Penrith City Council

RE: Development Application No.: DA16/1217

Subject: Response to preliminary assessment advice and document resubmission

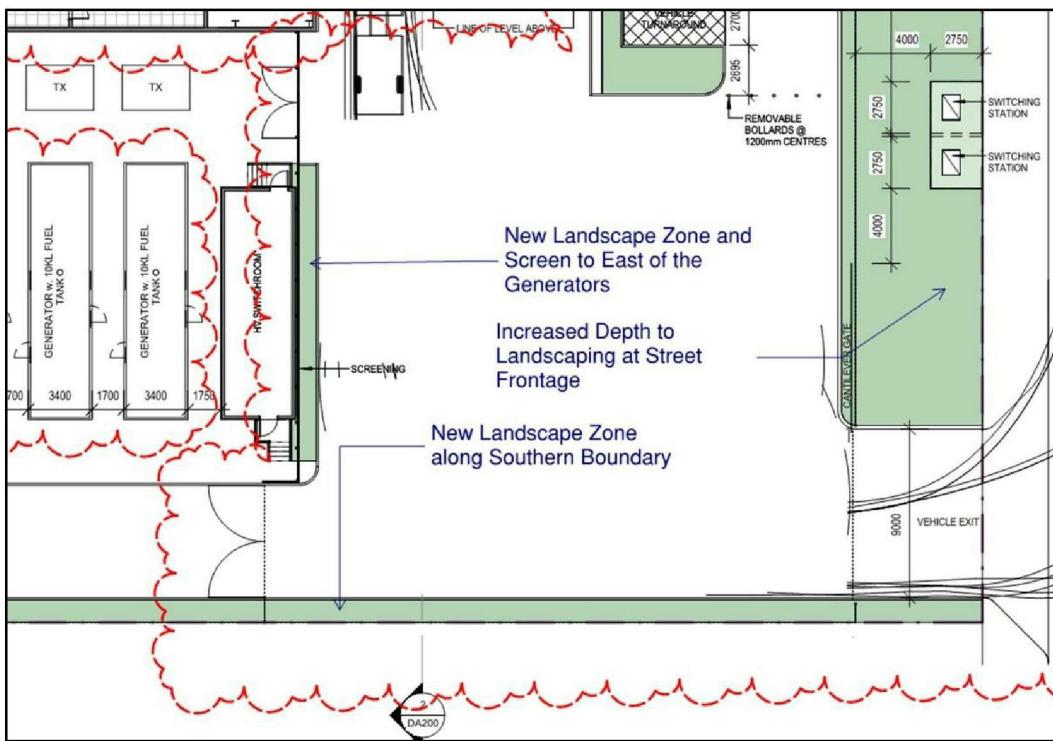
Item 1

Clarification of the purpose of the switching stations was requested and whether any alternative location is possible given their prominence within the front setback.

It is also noted that the original drawings submitted were confusing to the size and scale of these switching stations. I clarify that each switching station is approximately 1,350mm (w) x 950mm (d) x 1,800mm (h). A photo of the switching station is provided for reference.

The Medium Voltage Switching Stations at the front of the site provide power to the Data Centre facility, in addition to this we require redundant power supplies; hence the two sets of switching stations.

To maintain redundancy, we keep the two sets of incoming power supplies at opposite ends of the street frontage, so that should an incident occur in one location, it is unlikely to impact on the other location and we can still maintain power to the site without the use of generators.

In addition to this; Fire Hydrant and Sprinkler Booster services must be kept at least 10 meters from the switching stations to meet Australian Standards and to address safety concerns of the Fire Department. Due to the above requirements, there are three locations across the site where the site services are located.

The Switching stations are located at the front of the site because the power authority, Endeavor Energy, requires an easement and 24 hours access to the land that the switching stations is located. Due to the security requirements, this must be outside of the front fence.

Due to the concerns raised by Penrith City Council, we have removed the fence from around the switching stations, and they will now sit simply within the landscaped zone, like a typical kiosk substation found on many buildings in the area.

The revised architectural drawings better show the size of the switching station and I trust that the revised documents and the above clarifies the issue.
